INFORMATION BULLETIN

No.: V 508/6b - Revision No. 1 V 508E/2b

Refers to: Introduction of unified bolts and washers for all versions (models) of V 508

Avia Propeller Ltd.

Fig. No. 1. Differences of design and assembling of bolts and washers for propeller attachment to engine.

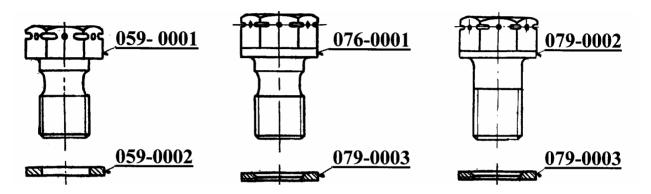
Combinations of bolts and washers of different versions see Fig. No. 1 on

one propeller are prohibited.

1st Version (Isn't allowable for V508E, V508E-AG, V510T series and for new and OH V508D-AG and V510AG series.) 2nd Version (Isn't allowable for V510T series and for new and OH V508D-AG, V 508E-AG and V510AG series.) 3rd Version (Is allowable for all V508 a V510 series.)

In such a case all bolts and washers for propeller attachment to the engine must be necessarily replaced by the new design ones.

Install washers with hole chamfer to bolt head.
